**Appl. No. 10/034,718**  
**Amdt. dated November 17, 2004**  
**Reply to Office action of September 8, 2004**

**Amendments to the Drawings:**

**FIG. 2**  
(PRIOR ART)

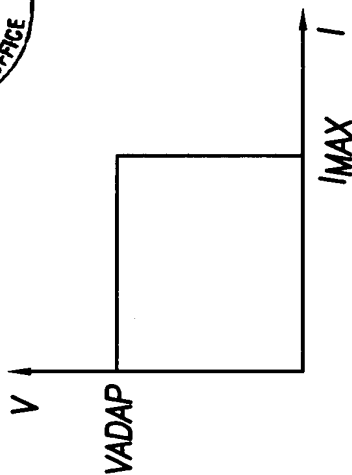
The Examiner objected to Figure 2 as being directed to prior art and required a legend entitled "Prior Art" to be included in Figure 2 per M.P.E.P. § 608.02(g) (rev. 2, May 2004). Accordingly, the Applicants have amended Figure 2 to comply with the requirements set forth in § 608.02(g).

The attached sheet of drawings includes changes to Figure 2. This sheet, which includes Figures 1-4, replaces the original sheet, including Figures 1-4. In Figure 2, the legend "Prior Art" has been added.
